COUNCIL ADVICE

Pre- EIS – SSD CONSULTATION

PROPERTY:	15-21 Cottonwood Crescent, Macquarie Park	
MEETING DATE:	29 January 2026	TIME: 10:00am
COUNCIL REFERENCE:	PRL2025/60	
DEVELOPMENT:	State Significant Development Application and concurrent rezoning to allow higher density residential development.

Figure 3: Section - Source: AJC

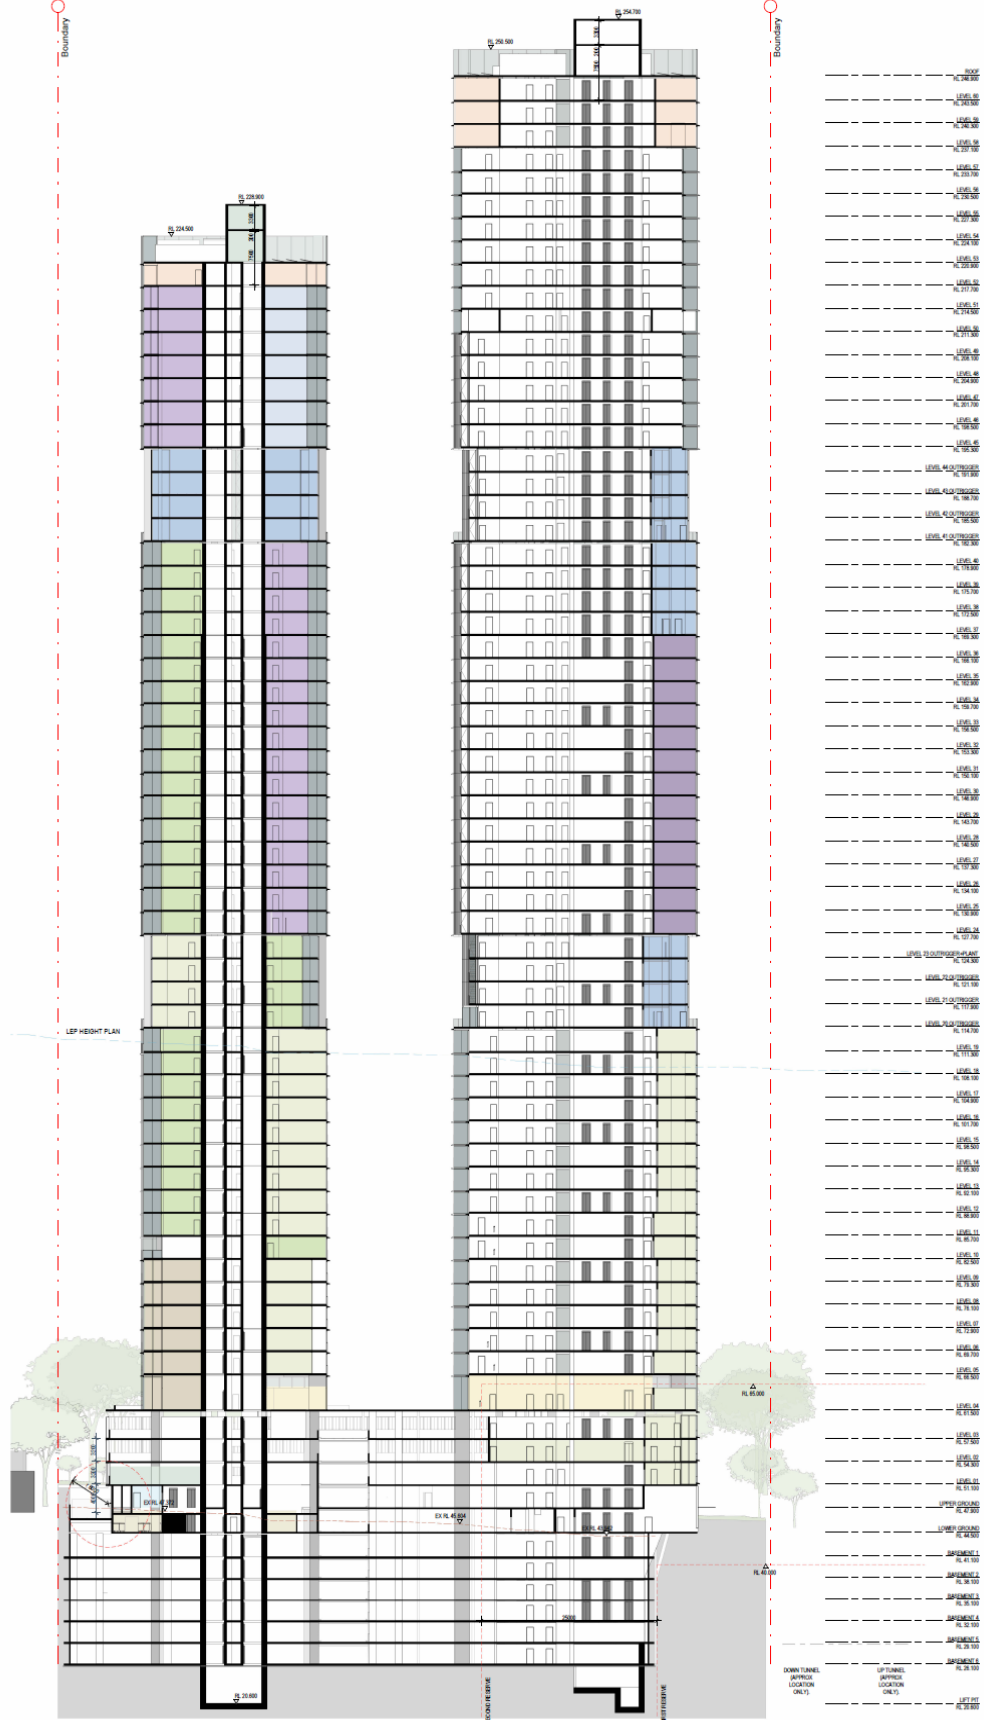
- a. Application needs to demonstrate and confirm that the basement crest level is designed up to the PMF. Cross sections of the basement along the driveway would be required.

- c. Architectural plans to reflect the following:
 - i. A cross section of the basement ramp to be provided and clearly demonstrate that the crest of the basement ramp is designed up to PMF level.

Figure 5: Plan showing Carprking interfacing with the Elouera Reserve

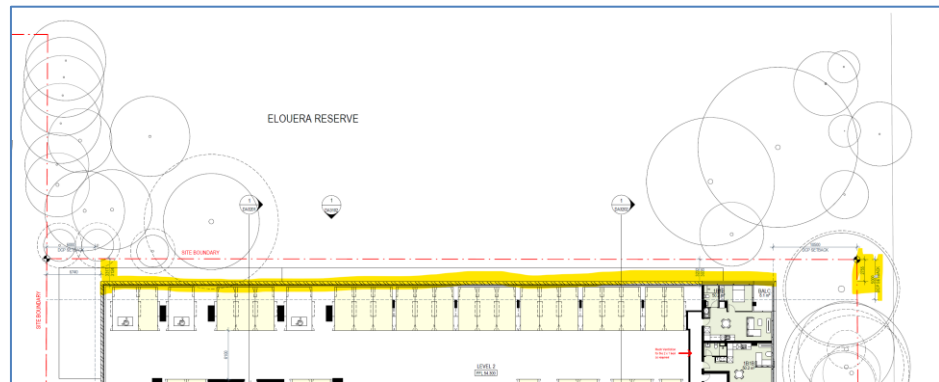
Varied setbacks are proposed along the western boundary adjoining Elouera Reserve. The podium levels (Level 1- 3) provide setbacks of less than 3 m, which does not comply with the minimum 5 m setback required under the Ryde DCP. It also presents a solid wall as an interface with Elouera Reserve, raising safety concerns that require a CEPTED approach.

It requires design considerations to minimise visual and environmental impacts from podium car parking, and provide better interfaces with Elouera Reserve.

It is recommended that all carparking is located below ground to improve the interface with Elouera reserve.

- iii. Ensure compliance with building setbacks controls and provide well-designed interfaces with streets and Elouera Reserve.
- iv. Locate all parking below ground and reduce car parking provision to reflect proximity to the metro station and minimise traffic impacts.

Figure 8: Existing removal / retention plans by Applicant

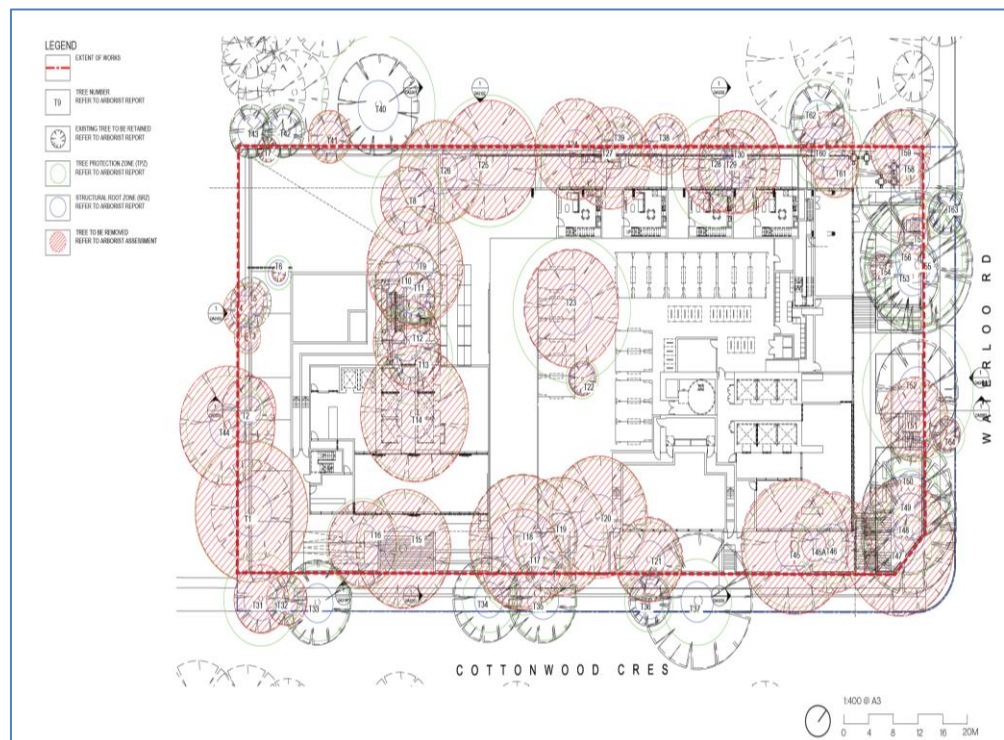
Existing mature trees along site boundaries currently provide shade and environmental value. The provided tree removal and retention plan indicates that most trees will be removed. All mature trees should be retained to the street edge at both Cottonwood Crescent and Waterloo Rd. Council requires a detailed arborist report for the removal of any existing mature trees.

- ix. Retain all existing mature trees to street interface (within 6m deep soil zone of the site boundary) enhance site landscaping.
- x. Provide compliant deep soil zones (minimum 6 m dimension, 7% of site area) in accordance with the ADG.

Figure 9: Deep soils Strategy shown in prelodgement Plans

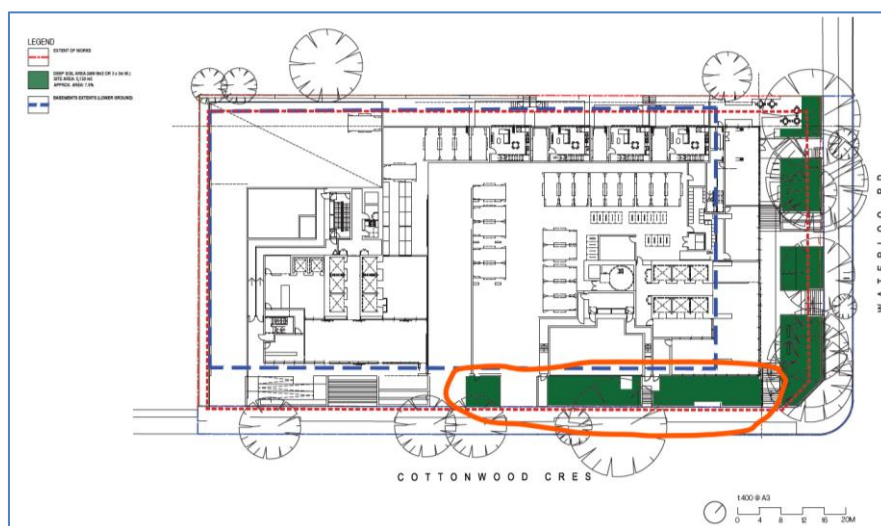
The ADG requires deep soil areas with a minimum dimension of 6m at either side, and a total deep soil provision of at least 7% of the site area.

Deep soil zones along Cottonwood Crescent fall within the 5m building setback area and therefore:

- do not meet the minimum dimension, and
- fail to achieve the minimum 7% requirement.

Figure 11: Rooftop communal open space at 82 Waterloo Road

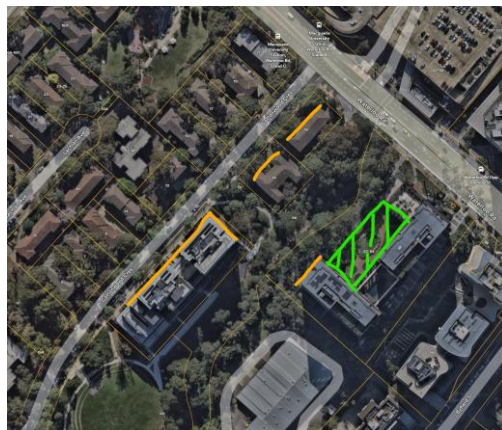
The proposed 205.5m height results in significant overshadowing of a broad south-eastern area, particularly impacts on:

- the solar access of the balconies and living rooms on the north-western facades of nearby residential buildings, and
- the rooftop communal open space at 82 Waterloo Road, highlighted in the snip below.
